Ecodesign and Labelling – Review of ENER Lots 1 & 2

Analysis and Recommendations

January 2026

Under the EU Ecodesign and Energy Labelling framework, products entering the Single Market must meet minimum environmental performance requirements and provide transparent information to end users. This position paper presents MARCOGAZ's views on the ongoing revision of Ecodesign and Energy Labelling Regulations for space and water heaters (ENER Lots 1 & 2).

Figure 1: EtaS calculation proposal from Annex III, for electric and hybrid heat pumps

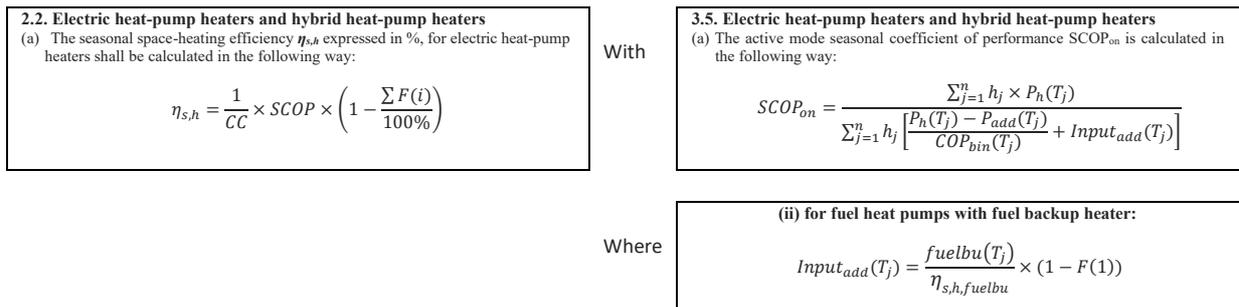
- To harmonise with electric heat pumps, the draft aligns the expression for SCOP_{on} (active mode) as seen in Figure 1, but it does not apply the conversion coefficient (CC) correction to the backup heater input as required by EN 14825 (Figure 2).
- Practically, **this treats the boiler backup as if it carried an electricity CC penalty**, inflating its primary-energy contribution by a factor of ~1.9 compared with the current standard practice.

Consequence: the hybrid's overall η_s is **artificially lowered**, not due to poorer real-world performance but because of a **methodological inconsistency** with EN 14825.

Under the **draft**, the boiler share is effectively **over-weighted** (as if multiplied by **CC = 1.9**), reducing the **computed** η_s versus today's EN 14825-consistent result—**even though the physical performance is unchanged**.

Marcogaz request: correct the hybrid calculation to remain compliant with **EN 14825**, ensuring the backup boiler input is treated with the **proper CC handling** (as in the current standard).

Figure 3: space heating energy labels and expected positioning of energy systems (Marcogaz)

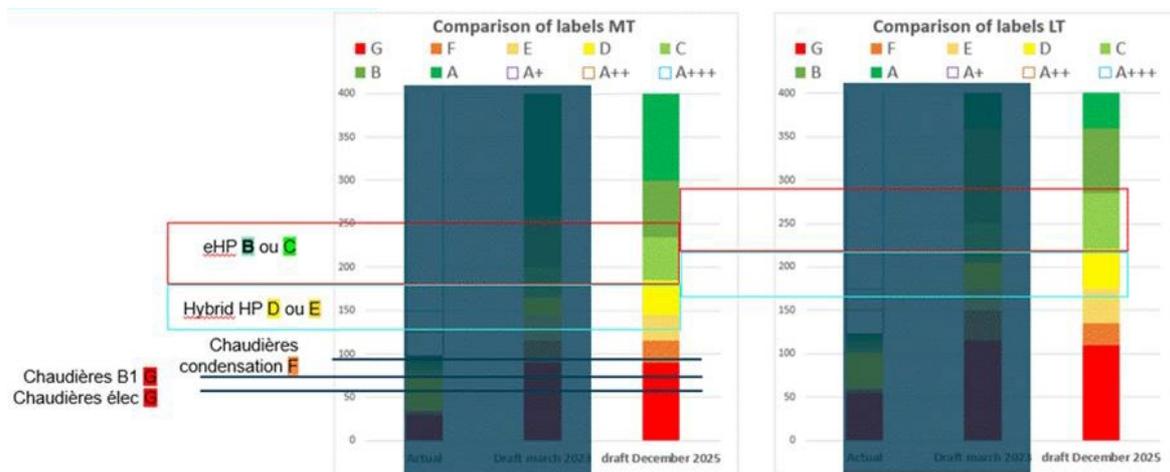
- B1 boilers and electric boilers would both receive a G label, despite a 30-point gap in seasonal efficiency. Label E should embark the best condensing boilers to highlight performance efforts.
- **Hybrid heat pumps may not reach label C in spite of performances equivalent to electric heat pumps, especially in high temperature emission, the lower level of label C should be adapted to include the best hybrid heat pumps.**

The proposal focuses only on medium and low temperature labels, while many appliances are installed in existing buildings without network modifications. Customers may expect higher performance than what is reflected in the proposed labelling.

Marcogaz supports a specific label for high-temperature appliances to ensure end-users receive complete and relevant information, through the then misused 2 temperature regimes proposed in Labelling, which may result in a change of appliance choice, or hopefully a decision for additional efforts in transitioning to medium or low temperature.
